802.3dj D3.2

Comment Resolution

Common Topics

Matt Brown (Qualcomm), 802.3dj Chief Editor
Tom Huber (Nokia)
Leon Bruckman (Nvidia)

Figure 178B–10a—Training control state diagram, part 1

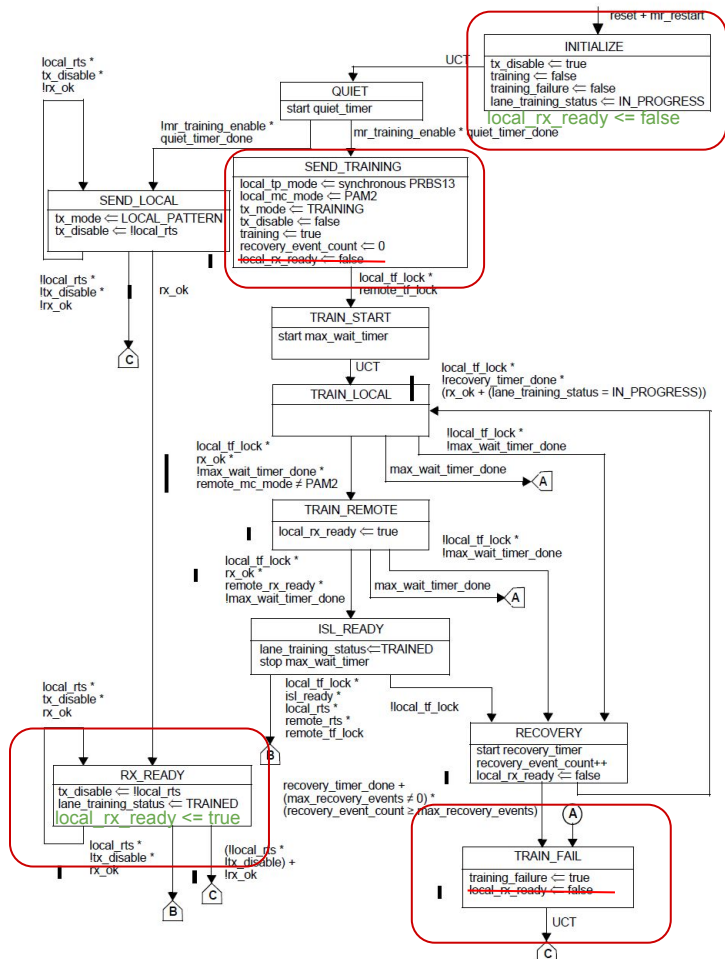
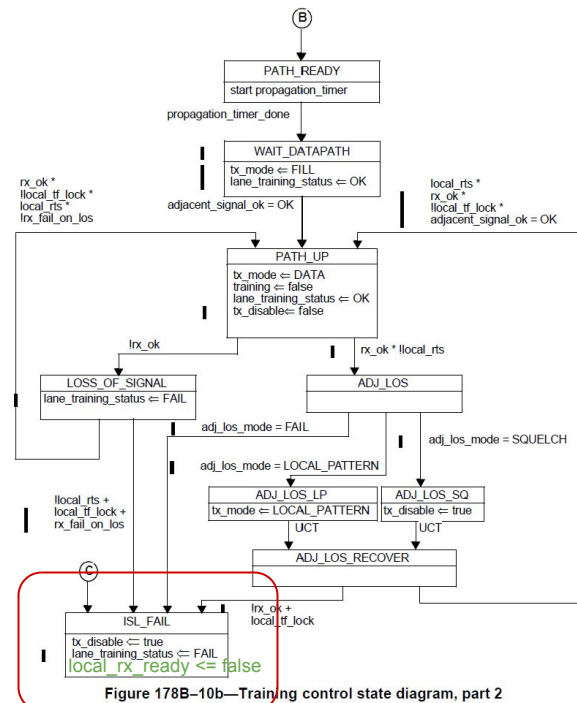
Comment R2-49

The D3.2 split of the D3.1 variable `local_rx_ready` into the new `rx_ok` (page 899, which took over the substantive "receiver is ready / no further adjustments required" definition and all the state-diagram conditions) plus a retained-but-redefined `local_rx_ready` leaves `local_rx_ready` inconsistent with its remaining consumers. Its definition is now reduced to "Boolean variable that indicates the state of the receiver. Its value is set by the training control state diagram (Figure 178B-10a).", which does not say which state of the receiver is indicated, nor the conditions for true and false. In Figure 178B-10a, `local_rx_ready` is set true only on entry to `TRAIN_REMOTE` and set false on entry to `SEND_TRAINING`, `RX_READY` (nearest numbered line, page 901 line 42) and `TRAIN_FAIL` - Figure 178B-10b never assigns it. It is therefore false throughout `RX_READY`, `PATH_READY`, `WAIT_DATAPATH` and `PATH_UP`, i.e. during normal data transmission. Three consumers were not updated and still cite `local_rx_ready`: `isl_ready` (178B.8.2.1, page 893, "set to true when `local_rx_ready` and `remote_rx_ready` are true for all lanes"), `PMD_signal_detect_i` (179.8.5, page 426 line 35, "the logical AND of the variables `local_rx_ready` and `remote_rx_ready`"), and register bit 1.1476.8 "isl ready" (45.2.1.169c, page 102 lines 24 and 26). Since `isl_ready` is also a condition in the RTS update state diagram (Figure 178B-9, page 896 lines 10 and 22) and on the `ISL_READY` exit (page 901 line 38), as drafted `isl_ready` and `PMD_signal_detect_i` can never remain true in the operational states. Separately, the `SEND_LOCAL` branch of Figure 178B-10a (entered from `QUIET` on "!mr_training_enable * quiet_timer_done") never assigns `local_rx_ready` at all, leaving it undefined whenever `mr_training_enable` is false, although `PMD_signal_detect_i` and management bit 1.1420.15 read it with no `mr_training_enable` guard.

Resolve the split consistently. Either (a) do not clear `local_rx_ready` on entry to `RX_READY` (and `TRAIN_FAIL` and the `PATH` states as applicable) so that it stays true from `TRAIN_REMOTE` through `PATH_UP`, and give it a substantive definition on page 898 stating the conditions for true and false - or (b) if `local_rx_ready` is intended only as the transmitted "receiver ready" status bit of the training frame, restate the consumers in terms of `rx_ok`: change `isl_ready` in 178B.8.2.1 (page 893) to "set to true when `rx_ok` and `remote_rx_ready` are true for all lanes of the interface", change `PMD_signal_detect_i` in 179.8.5 (page 426 line 35) to "the logical AND of the variables `rx_ok` and `remote_rx_ready`", and update the 1.1476.8 descriptions in 45.2.1.169c (page 102 lines 24 and 26). In either case add "`local_rx_ready <= false`" to the action block of the `SEND_LOCAL` state in Figure 178B-10a (page 901 line 13) so the variable is defined on the non-training path.

ACCEPT IN PRINCIPLE.

Make the following changes to Figure 178B-10a/10b.

- In the `SEND_TRAINING` and `TRAIN_FAIL` states, delete "`local_rx_ready <= false`".
- In the `INITIALIZE` and `ISL_FAIL` states, add "`local_rx_ready <= false`".
- In the `RX_READY` state, add "`local_rx_ready <= true`".

Figure 178B-10b—Training control state diagram, part 2

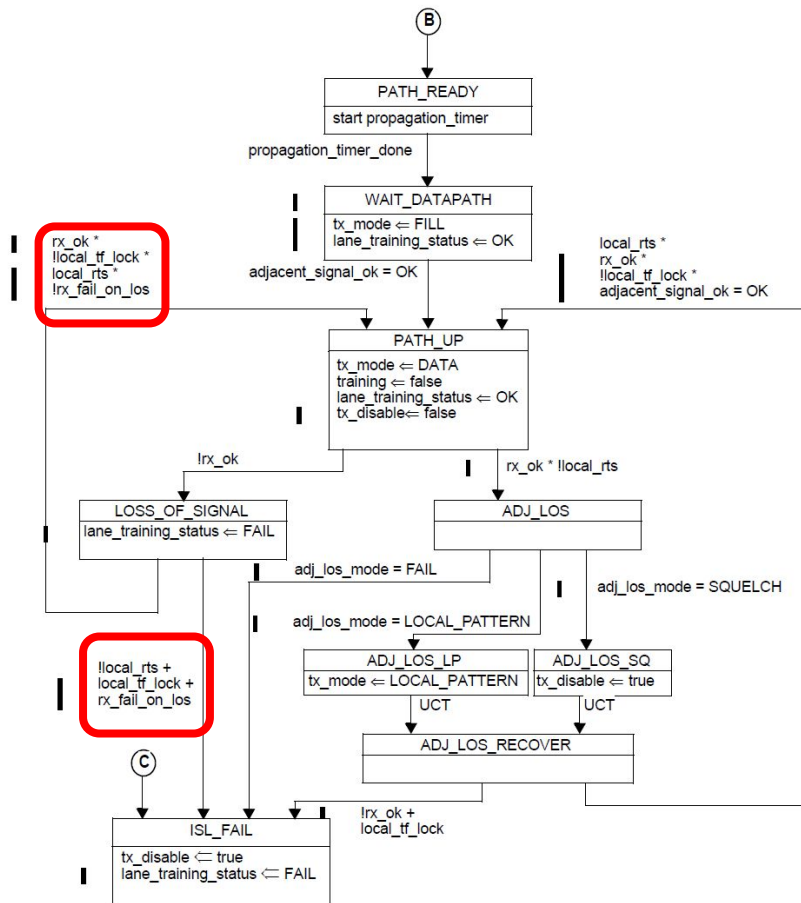
Comment R2-110

rx_fail_on_los is defined as an ability (per the register bit, as noted in the editor's note), but in fact it is a "disability" - the receiver can't do anything but fail upon a LOS event. Even if this is treated as an "inverted ability bit", it is possible that the receiver can, by design, recover without failing (so rx_fail_on_los is false), but management prefers to force a restart on every failure. This is not supported by the current definition (read-only).

The common way to specify management variables is ability + enable as separate variables. The suggested remedy adds these management variables while keeping the semantic of rx_fail_on_los, so the state diagram is not changed.

rx_los_recovery_ability: Boolean variable that indicates that when the training control state diagram (Figure 178B-10b) is in the PATH_UP state, the receiver can recover from loss of signal (rx_ok = false) without a restart of the ILT function. The value of this variable is implementation dependent.

mr_rx_los_recovery_enable: Boolean variable that is set by management to enable recovery from loss of signal. The default value is false.

rx_fail_on_los: Boolean variable that is true when either rx_los_recovery_ability or mr_rx_los_recovery_enable is false, and false otherwise.

PROPOSED ACCEPT IN PRINCIPLE.

Implement suggested remedy except define mr_rx_los_recovery_enable as follows.

"mr_rx_los_recovery_enable: Boolean variable that is set by management to enable recovery from loss of signal without a restart of the ILT function. The default value is false."

Implement all with editorial license.

Figure 186-3—800GBASE-ER1 FEC functional block diagram

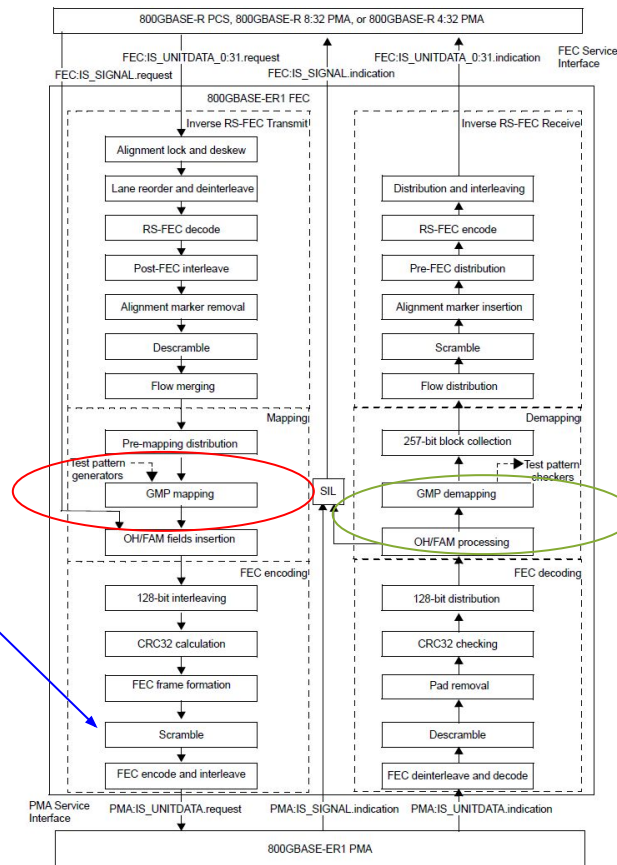
In the first row, the value is "FEC:IS_UNITDATA.request" but this is a name of a service interface primitive, which communicates the input from the client (PCS or PMA). It does not describe the payload, because the payload is the output of the "Pre-mapping distribution" block (based on Figure 186-3) which has gone through the "inverse RS-FEC transmit" processing.

In summary, the payload depending on FEC:IS_SIGNAL.request(SIGNAL_OK) is either the output of the "Pre-mapping distribution" block, or the encoded PRBS31 test pattern generator; this would match Figure 186-3. There is no "scrambled idle" or "LF" generator in the transmit direction.

The GMP mapper must always have data to map. This is not adequately described in the current text.

- In normal operation that is the signal coming from the AUI, as transformed by the processes prior to the GMP mapper (which is not FEC:IS_UNITDATA.request).
- During APSU, the signal from the AUI is not forwarded, so a replacement is needed.
 - In typical implementations of this type of interface, this is a test pattern or Idle signal
 - Exactly what it is doesn't really matter since it won't be forwarded and there is a scrambler before FEC encoding
- If the AUI is failed, LF should be inserted in the transmit function

Add to the end of 186.2.3.1.7:

"When IFEC_align_status is true, this stream is provided to the pre-mapping distribution function. Otherwise, a stream of 257-bit blocks containing local fault ordered sets is provided to the pre-mapping distribution function."

Replace first paragraph of 186.2.3.3:

"The input to the GMP mapper is either the stream of 257b blocks output from the pre-mapping distribution function or the output of the test pattern generator (see 186.2.3.12)."
